Wallingford Sports Park – Outcome of Community Consultation – August 2024

EXTRACTS FROM CONSULTATION BOARDS – OPTIONS 1, 2 & 3 (to aid understanding of the survey results)

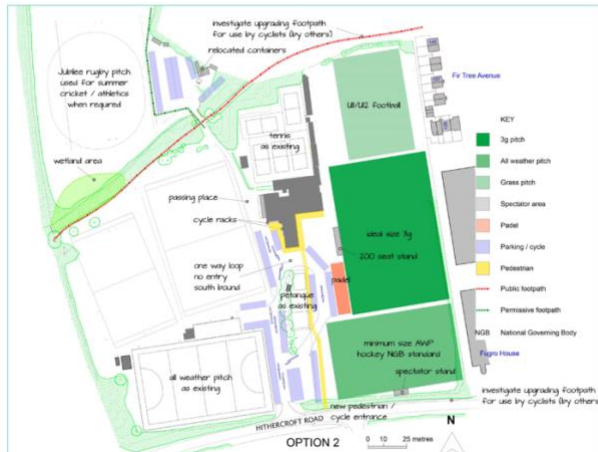
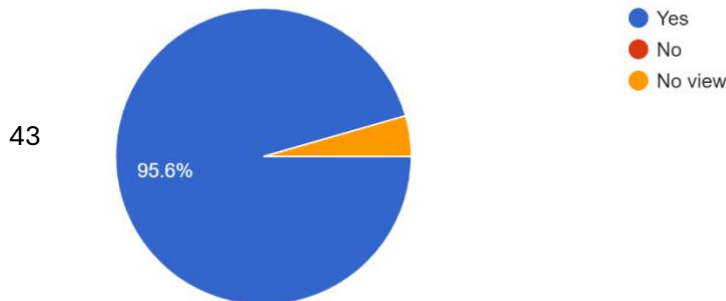
1. If the 3G pitch was located as in option 1 and hockey as in option 3 could this allow more flexibility of use of the pitches nearest Fugro?
2. As mentioned previously some facilities for changing and toilets over the brook to support Cricket, Rugby, Archery and other sports that could be held over there.

5. AWP on Rugby training pitch, 3G on Stadium and two grass football pitches left as is to retain option for Cricket
6. Pedestrian access from the Hithercroft Rd/Fugro corner.

8. Rain gardens as part of the drainage strategy, using rain water on site rather than just slowing the rate of discharge off the site
9. Has the joining of the existing and new AWPs been considered for option 3? Appreciate this would remove the additional new parking located the other side of the AWPs but wondering whether the two being connected and having a warm up area in the space between them may have some value?

11. the new area created by the house estate could be an ideal area for a cricket and athletic track
12. No wetland area as this could potential cause grass pitch drainage issues. Cricket to move to the far end of jubilee by Highcroft. I would prefer a combination of option 1 and option 2 where the main football pitch is not moved but the cricket option is moved to the far end of jubilee field.

13. options 1 and 2 would be better with a warm up hockey area as on saturdays there will not be space on the existing warm up area for 4 teams to warm up prior to their matches

14. Option 2 - needs the cricket and athletics moving further away from the main pitch. Option 3 - This has come yup many times, the astro will not fit here. If it is pressed ahead despite not fitting, it will destroy the grass pitch during construction. Option 1 - Not sure how this works, as the summer is the time the pitches Arte allowed to recover and prepared for the winter season.

15. Option 1: Moving the padel courts in between the AWP and the grass area makes sense because:
 - the football club retain the grass area for overspill for training when fixtures take place

16. Option 1 - the National Sports centre in Bisham has restricted use of its floodlit pitches because local residents complained. It's important to look after the locals which you have mentioned. Option 2 doesn't flow as well, and the AWP is minimum size. Option 3 flows better but it's not ideal that 3G and AWP are minimum size.

17. I still don't feel any of the options resolve the significant issue of lack of parking. Is it inconceivable to suggest that one of the areas set aside for grassed facilities is turned into a large car park with permeable ground covering? Whether it's one of the grass football areas or the back field? This could potentially allow one or more of the new pitches to become of ideal size rather than minimum size.

20. Summary Pétanque club members verbal views Option 1 Concerns over loss of parking on grassed area adjacent to the piste Provide parking for blue badge holders Affect of parking on the trees Provide wind break to south west corner of pistes Option 2 Concerns over loss of parking on grassed area adjacent to the piste Provide parking for blue badge holders Affect of parking on the trees Provide wind break to south west corner of pistes Two way / one way system does not seem to work very well Pedestrian / cycle path has to cross road twice. Not efficient use of space; lots of white areas Option 3 Concerns over loss of parking on grassed area adjacent to the piste Provide parking for blue badge holders Affect of parking on the trees Provide wind break to south west corner of pistes Did not like padel at front of park; why not with tennis Will feel hemmed in with 3g so close Football players crossing the piste and over fences already an issue; 3g will make it worse
